## REMARKS

Claims 2-18 remain in this application. Claims 1 and 19 have been canceled. Claims 2, 4, 5, 8, 13, and 17 have been amended.

FIG. 1

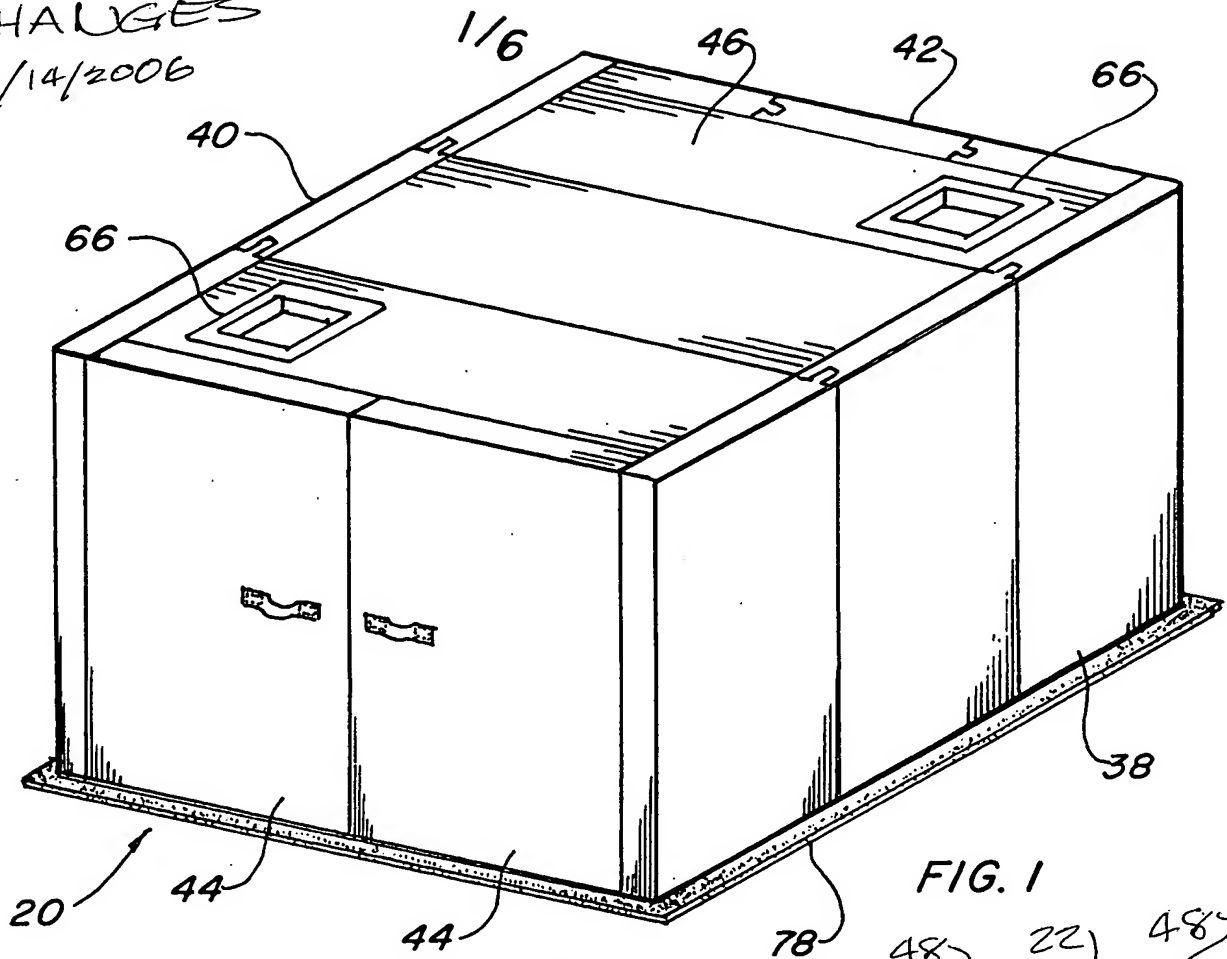
The drawings were objected to under 37 CFR 1.83(a) as they must show every feature of the invention described in the specification and specified in the claims. The examiner indicated that the hook and loop fastener attached by overlapping the fasteners from adjacent panels around the frame must be shown or the feature canceled from the claims. Applicant is furnishing a replacement sheet illustrating the overlapping hook and loop fastener over the frame in the cross section of the added FIGURE 3a. Since the hook and loop fastener known by its trade name VELCRO is well known in the art and the fact that which side of the hook or loop is physically located is irrelevant as they are completely interchangeable. No new matter has been added as the drawings illustrated their presence as element 64 and the specification clearly disclosed their location on each side of the frame.
